ENGINEERING ORDER

1. ENGINEERING ORDER NO.: 2021A0059-T
2. RELEASE DATE: 2021-03-11

3. DWG TITLE: YAW ELECTRICAL CONTROL UNIT
4. DWG ODA CAGE CODE: 017N4
5. DWG NO.: 1925900-3
6. DOC TYPE:
7. NEXT HIGHER ASSY:
8. USED ON: B-52
9. OPR CAGE CODE: 98748
10. DWG SIZE: E
11. DWG SHEET(s) AFFECTED: 0001
12. LATEST DWG REV:

This EO replaces EO 2014A0354-T.

32 (CONT). DESCRIPTION OF APROVED CHANGES/REMARKS - *CONTINUED FROM PREVIOUS SHEET*

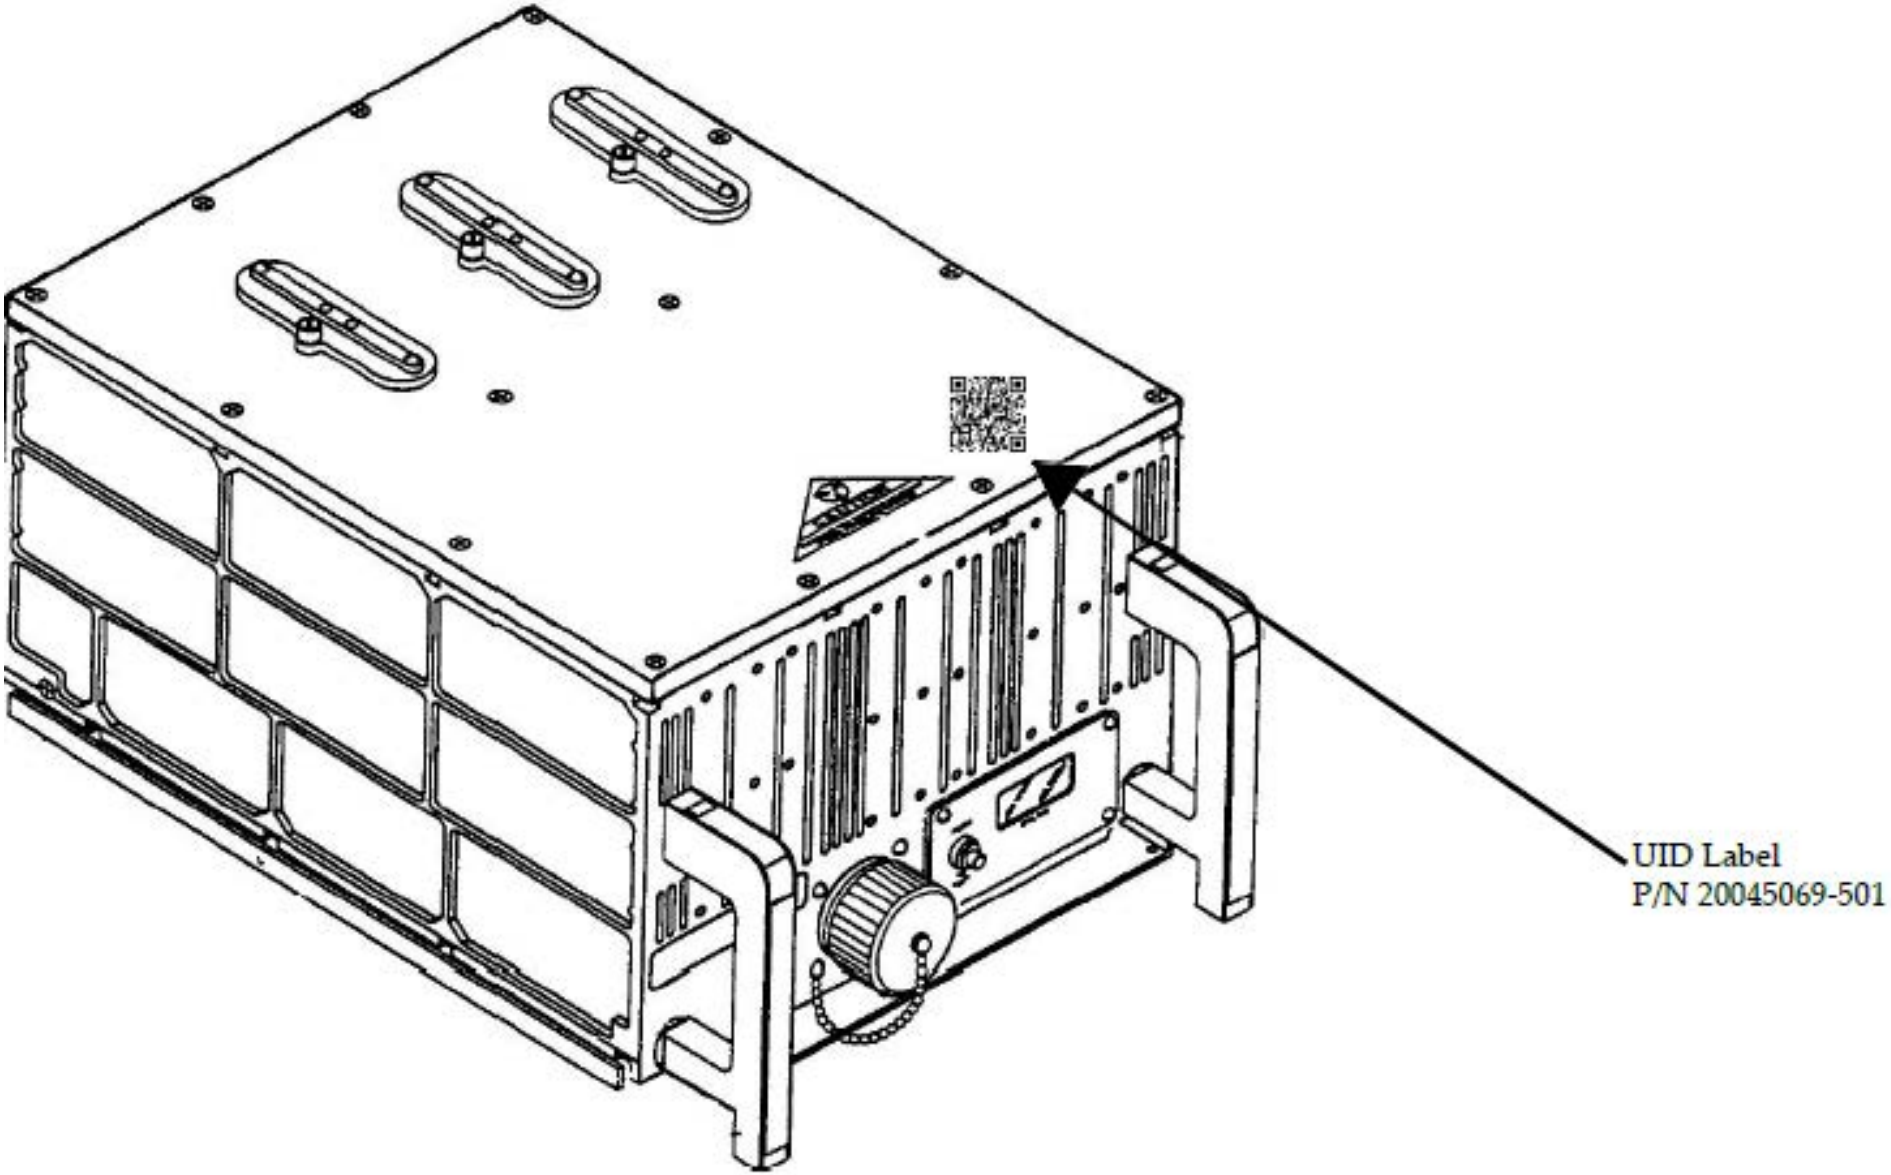
- B-52 YAW ELECTRICAL CONTROL UNIT (PN 1925900-3) shall be marked with a Unique Item Identifier (UII). (REF: MIL-STD-130)

- If no UID label is present, fabricate new UID label (200945069-501) to attach to end item (PN 1925900-3).

- New UID label will be located on the end item as shown in sketch/photo on page 2, AF form 3926.

(UID Label P/N 200945085-011A is an acceptable alternate part)
